City of Puyallup
Development
Engineering
APPROVED

EAST TOWN CROSSING
BUILDING 'G'
PIONEER & SHAW PUYALLUP WA

TITLE: SITE PLAN - REF. ONLY

AS1.0

1 OVERALL SITE PLAN - PHASE 1
SCALE: 1" = 40'

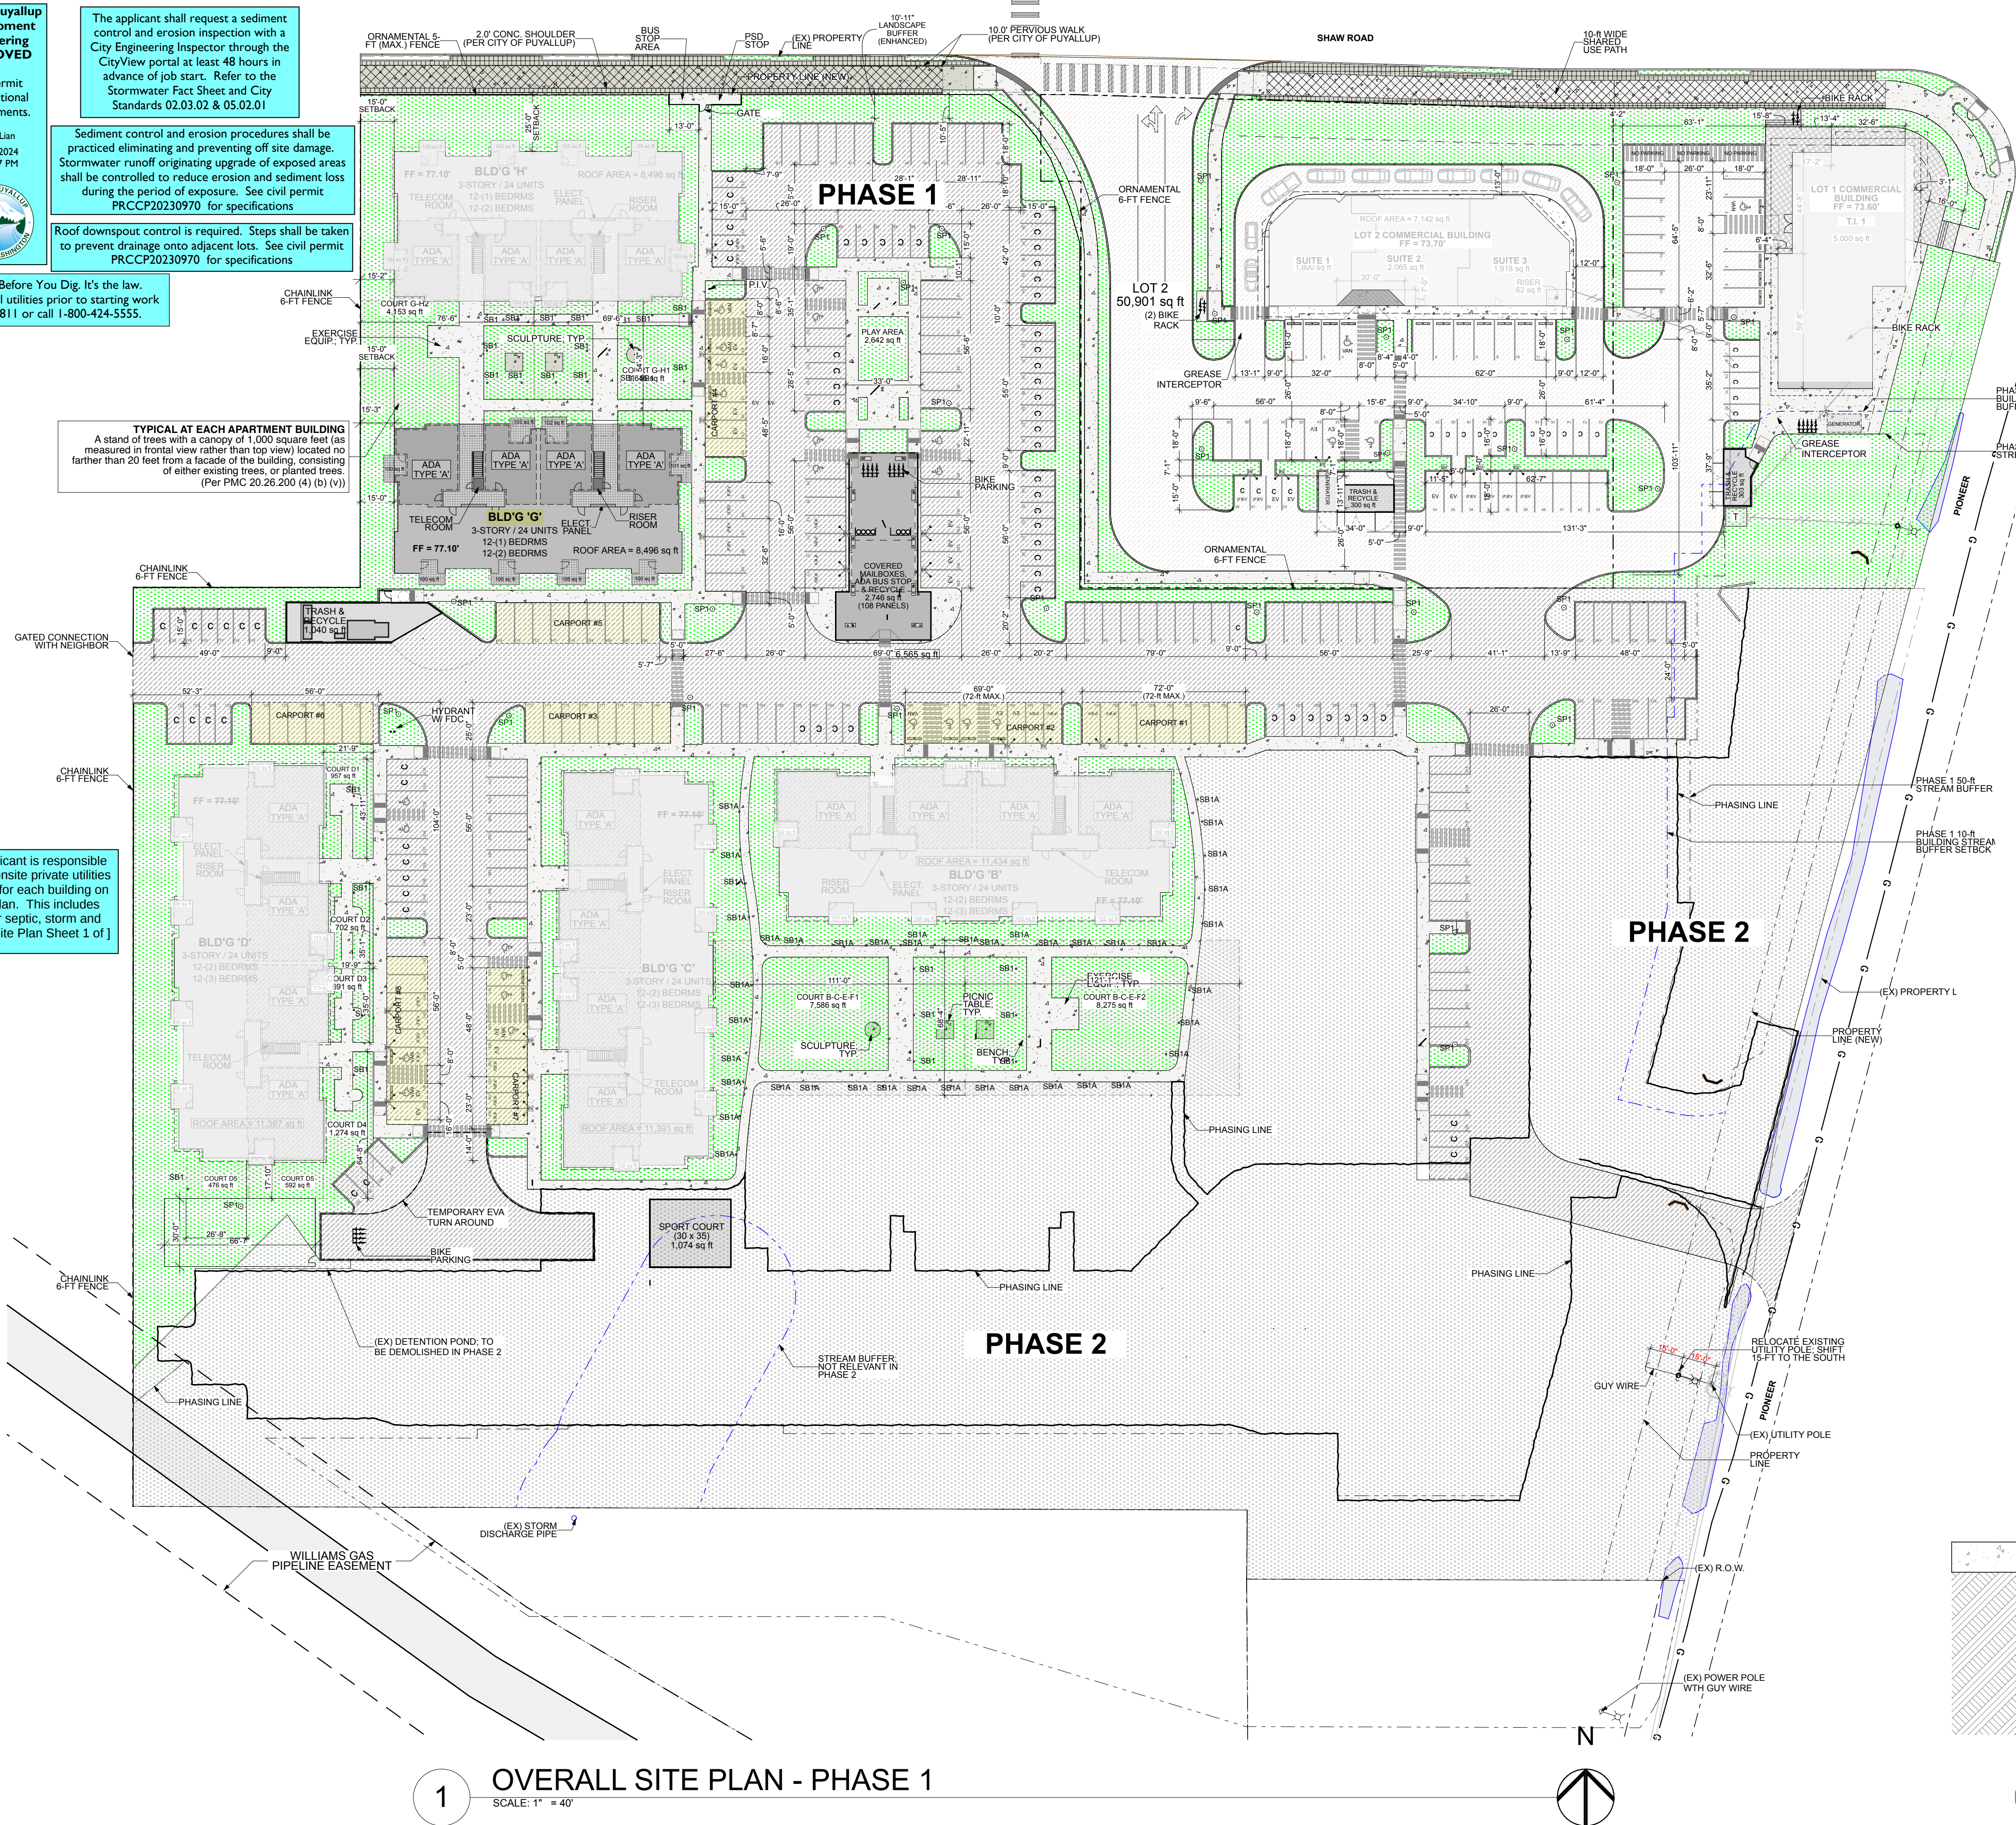
The applicant shall request a sediment control and erosion inspection with a City Engineering Inspector through the CityView portal at least 48 hours in advance of job start. Refer to the Stormwater Fact Sheet and City Standards 02.03.02 & 05.02.01

Sediment control and erosion procedures shall be practiced eliminating and preventing off site damage. Stormwater runoff originating upgrade of exposed areas shall be controlled to reduce erosion and sediment loss during the period of exposure. See civil permit PRCCP20230970 for specifications

Roof downspout control is required. Steps shall be taken to prevent drainage onto adjacent lots. See civil permit PRCCP20230970 for specifications

TYPICAL AT EACH APARTMENT BUILDING
A stand of trees with a canopy of 1,000 square feet (as measured in frontal view rather than top view) located no farther than 20 feet from a facade of the building, consisting of either existing trees, or planted trees. (Per PMC 20.26.200 (4) (b) (v))

The applicant is responsible to show onsite private utilities services for each building on a site plan. This includes sewer or septic, storm and water. [Site Plan Sheet 1 of 1]
